HPC-23-08-Steel Façade Certificate of Compliance

May 17, 2023

To: Historic Preservation Commission
From: Wade Broadhead, Senior Planner
Through: Scott Hobson, Acting Director of Planning and Community Development
Location: 326 S. Union Ave
Applicant: Fred Gonzales
Owner: Henry Borunda
Year Built: Remodeled 1945
Legal Description: Lot 4, Block 58, South Pueblo
Zone District: HB, Historic Business Zone District

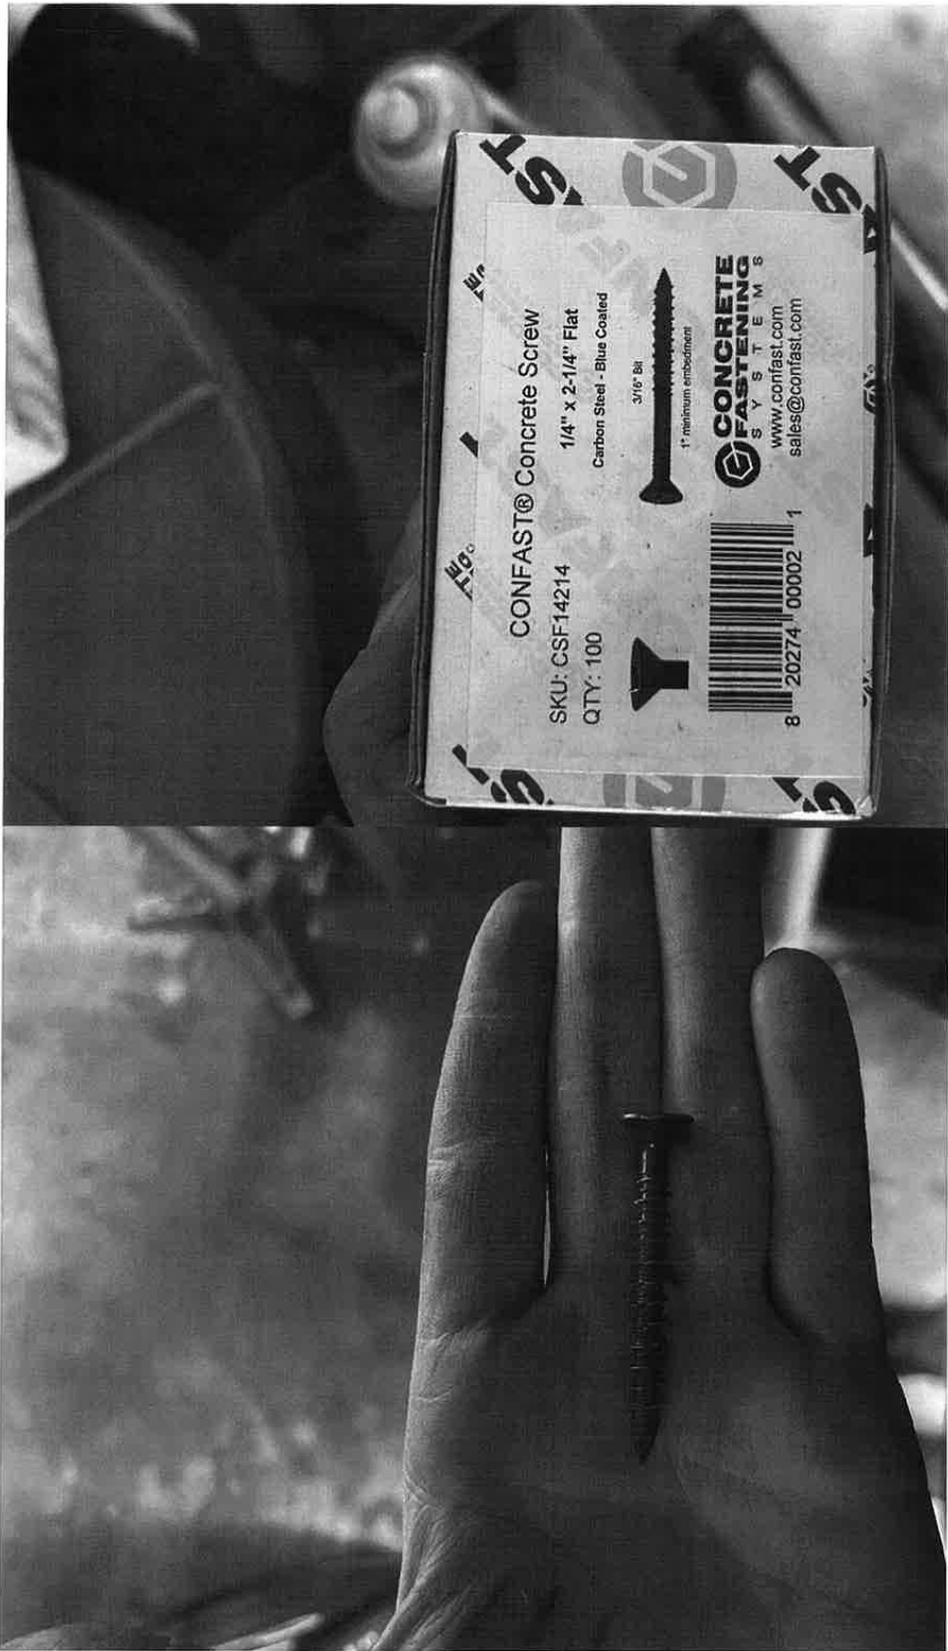
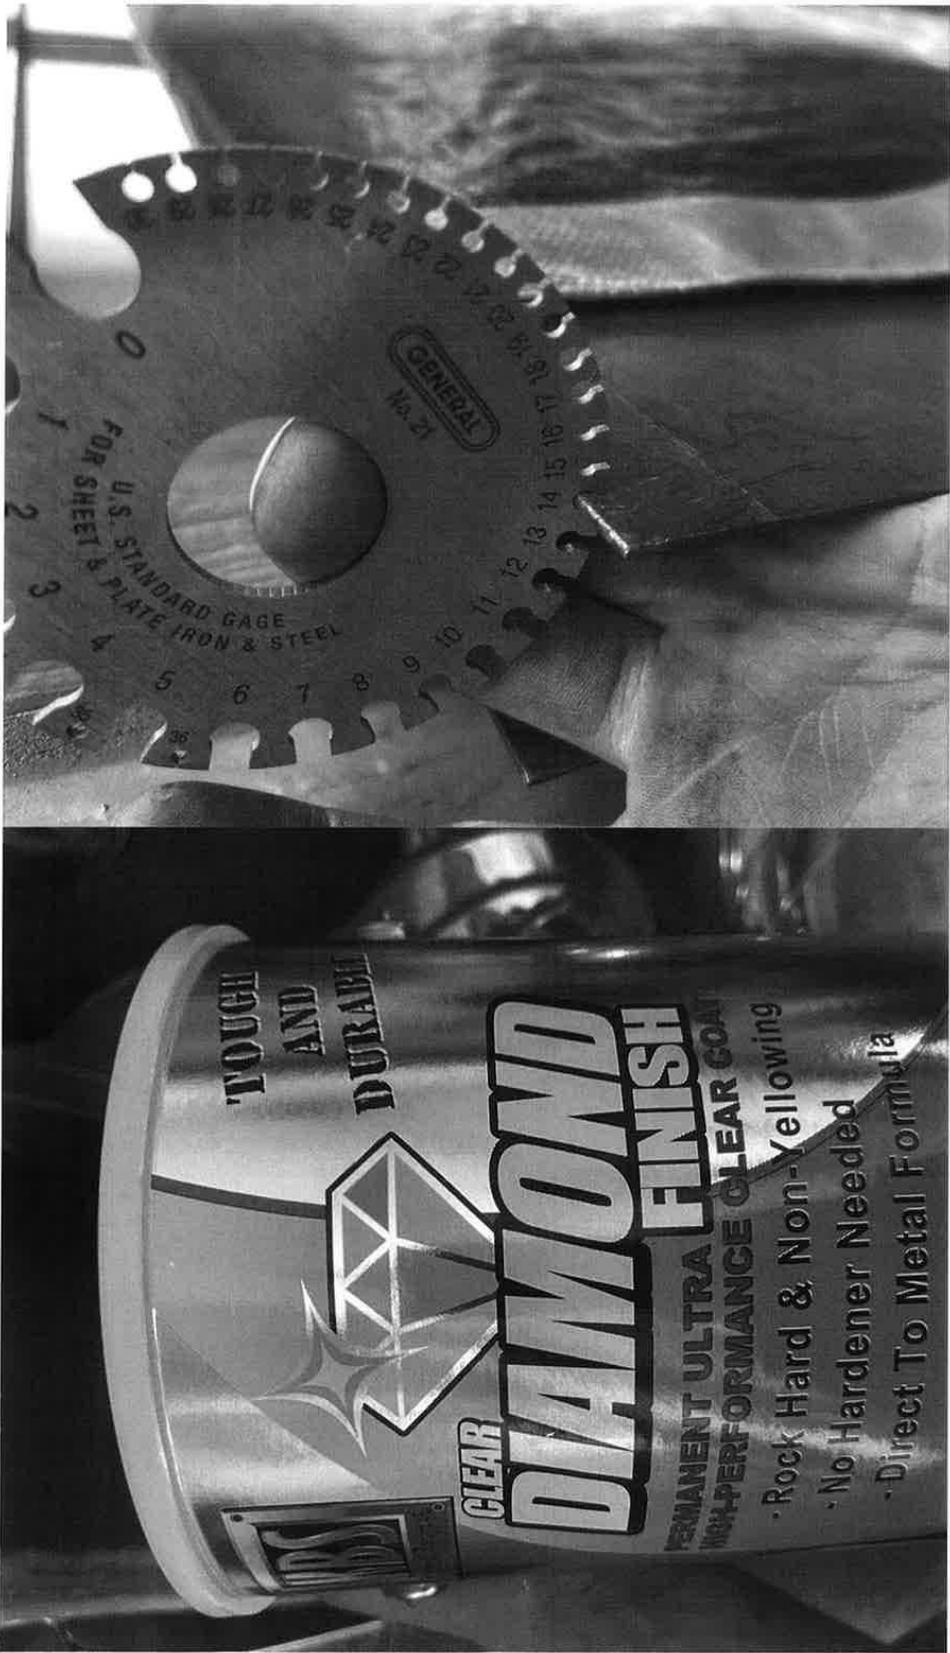
Negative Finding The alteration obscured and damaged original significant historical material that contributed to the overall feel of the Union Avenue National Register District and while the Historic Business District Zoning Guidelines give flexibility to the alteration of noncontributing buildings, the guidelines clearly state that existing historic material should not be destroyed. The steel façade does not match existing architectural details in color, not texture, nor material type and is a significant deviation from the original blonde colored brick and block façade. The steel façade system is not compatible with the existing structure.

Staff recommends denial.
